Adequacy Review No. 1, TR-7, Home Office Mine, M1977-439

EXISTING CONDITION FLOODPLAIN AND FLOODWAY WORKMAP

MARTIN MARIETTA MATERIALS TAFT HILL SITE

2D Max Velocity Results.png
1982K

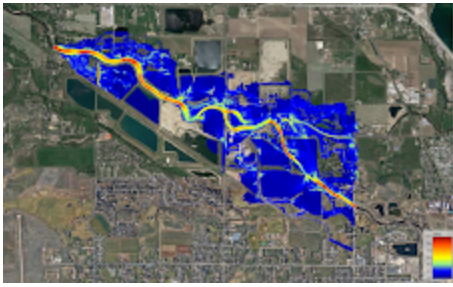
- Comment #2:
 - A velocity output map from the 2D modeling results is attached. A more zoomed in picture of the northeast corner of Pit E-I is also attached and shows velocities of 1 ft/sec or less in this area. If further output data

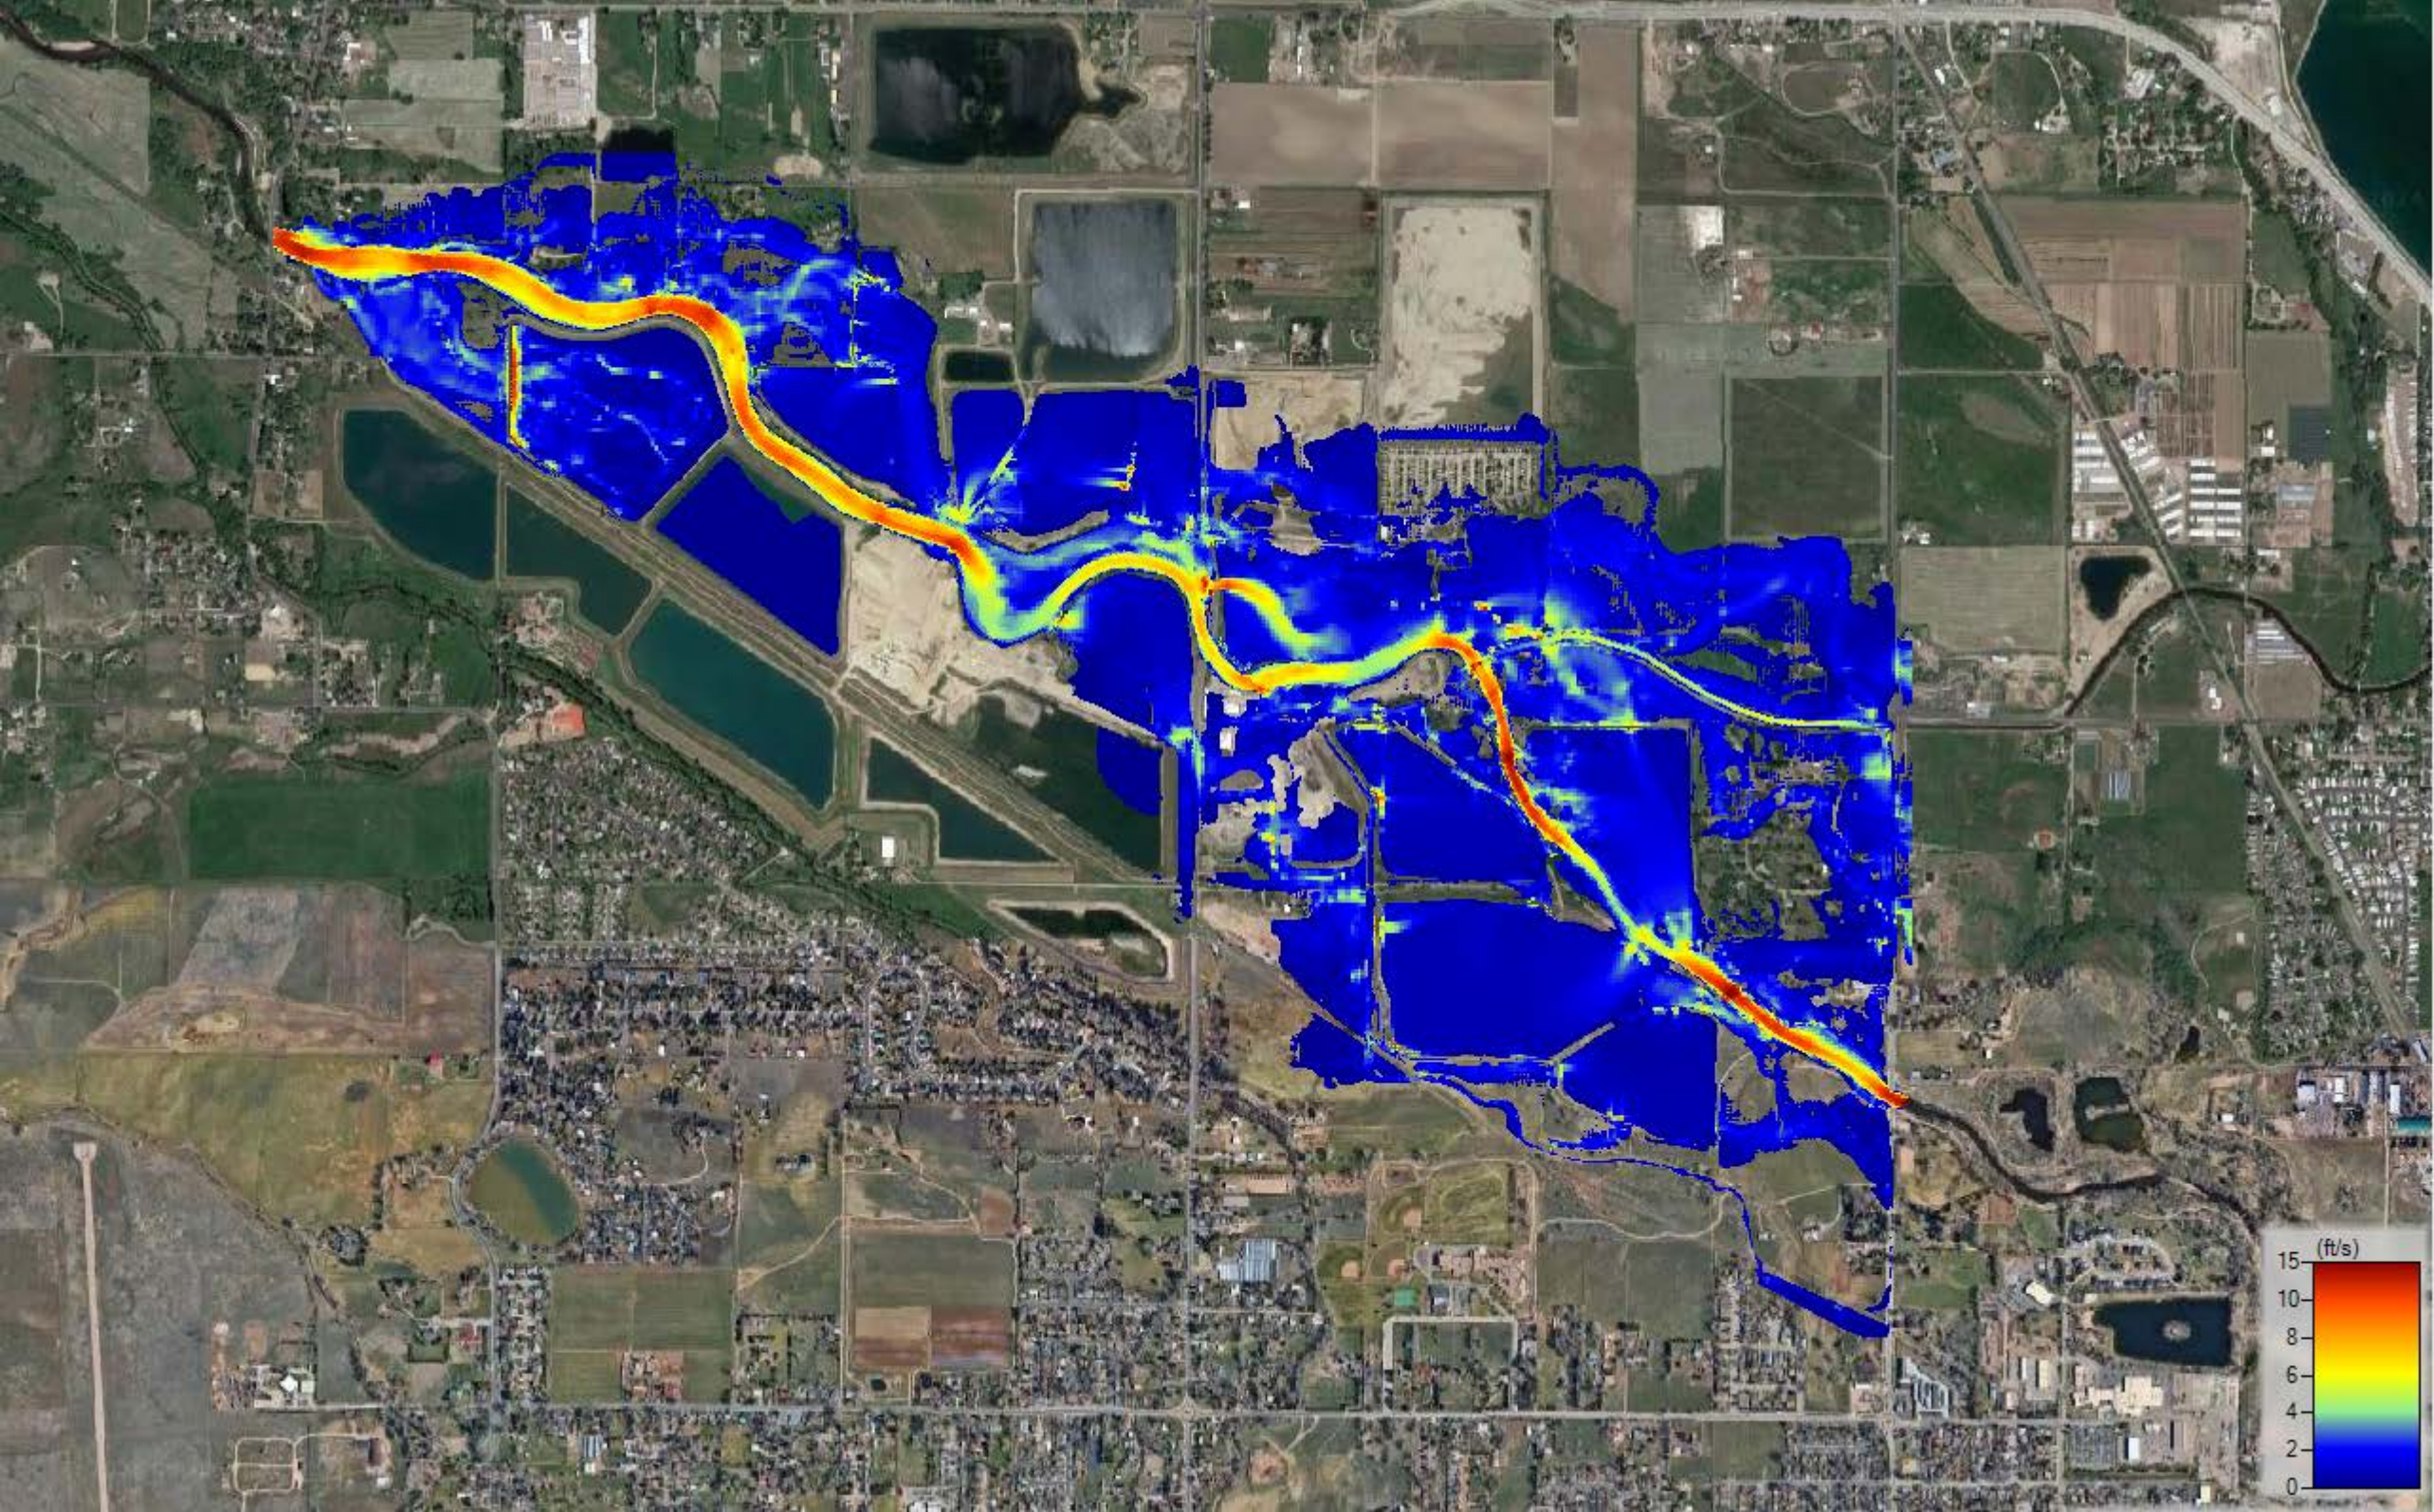
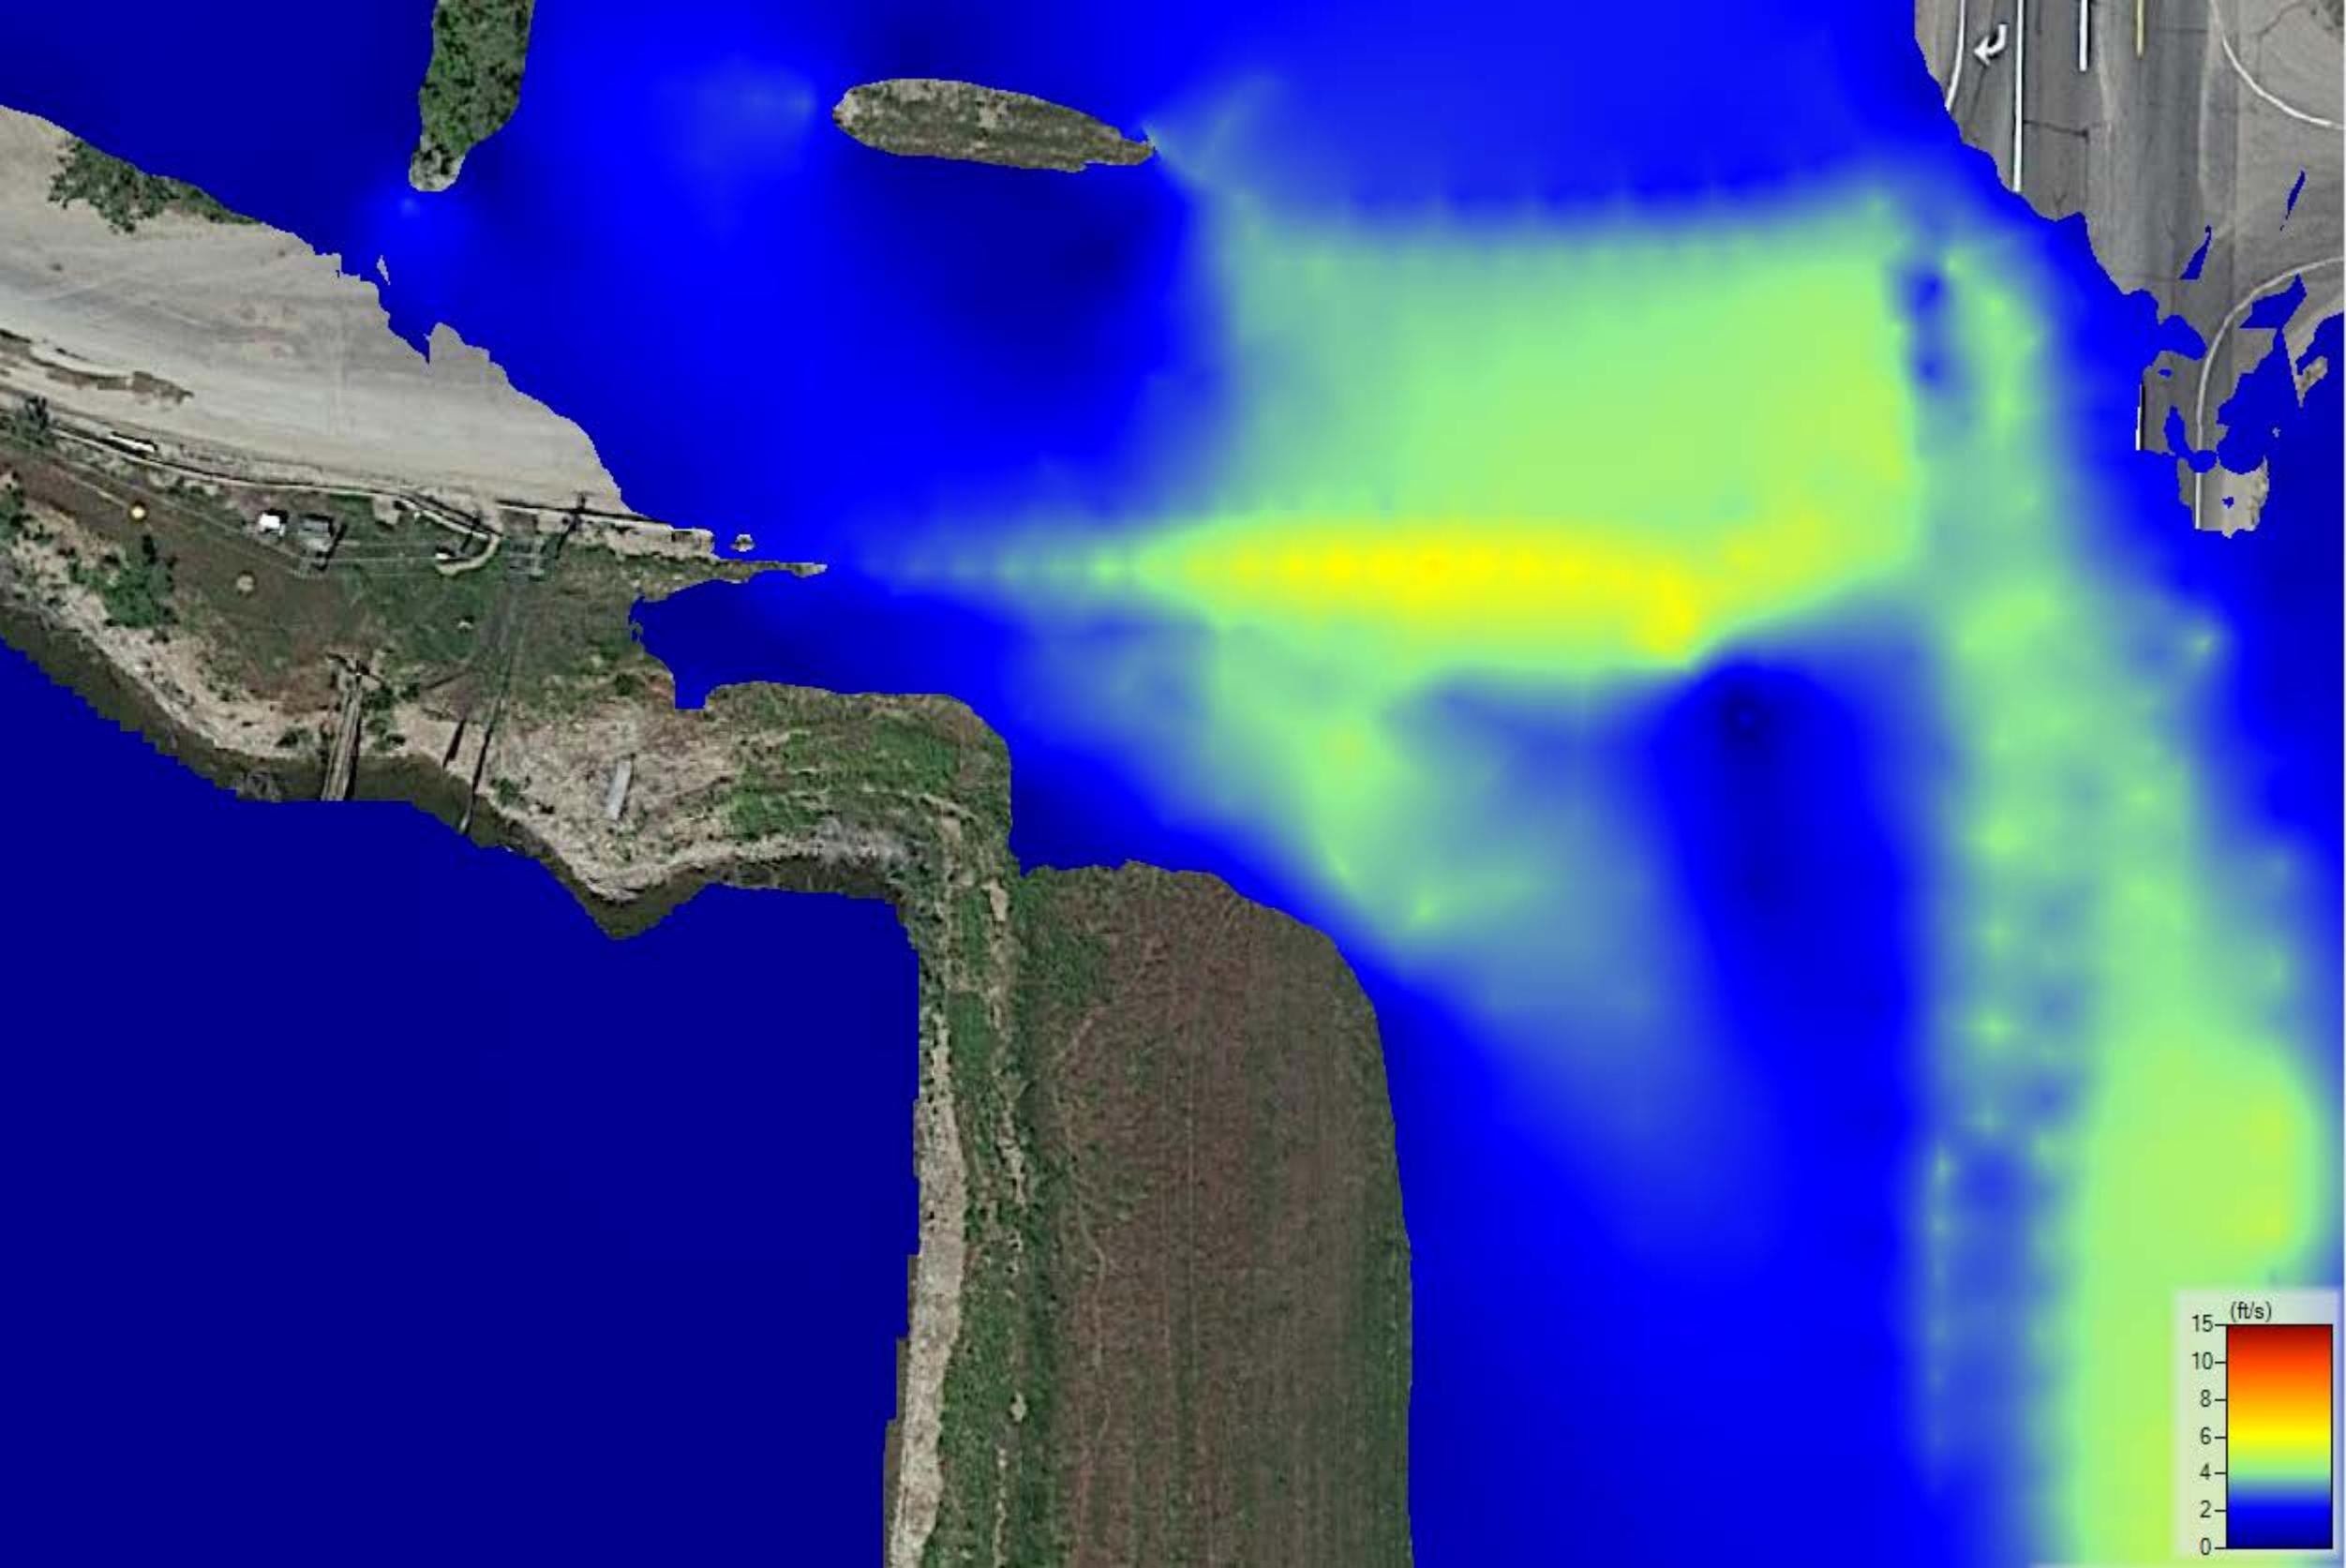
- Comment #1:
 - As discussed in the submitted technical memo, two sets of hydraulic models were utilized for the analysis. A one-dimensional model with cross sections was prepared back in 2014-2015 using HEC-RAS Version 4.1. Cross Section print outs from this model are attached with annotation noting which ones are Sections CV, CW, and CX. Please note that the 1D model utilized split flow paths, so cross section print outs are provided for both the main channel and right split flow path. The cross section numbers noted on the attached pdfs correlate to those shown on Figure 2 in Attachment C of the memo. This figure has been attached to this e-mail for reference and has been annotated to show which cross sections are contained along the Right Split Flow Path.
